PCN# : P544AAB
Issue Date : May. 15, 2015

DESIGN/PROCESS CHANGE NOTIFICATION

Top & side view

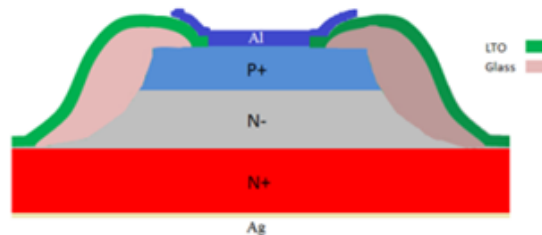
Description of Change (From) :
Fab process : GPP (Glass Passivation Process)

Top & side view

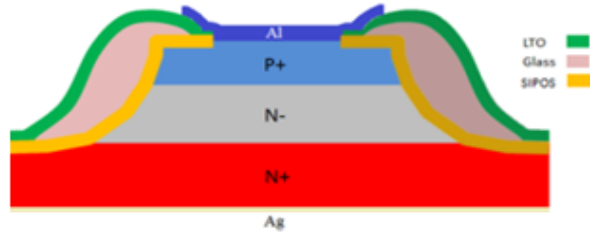
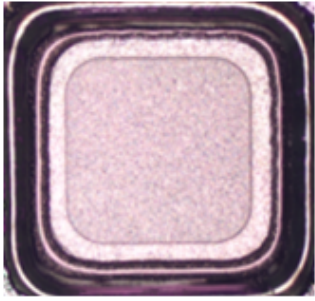
Description of Change (To) :
Fab process: GPP with SIPOS (Semi-Insulation Polycrystalline Silicon)
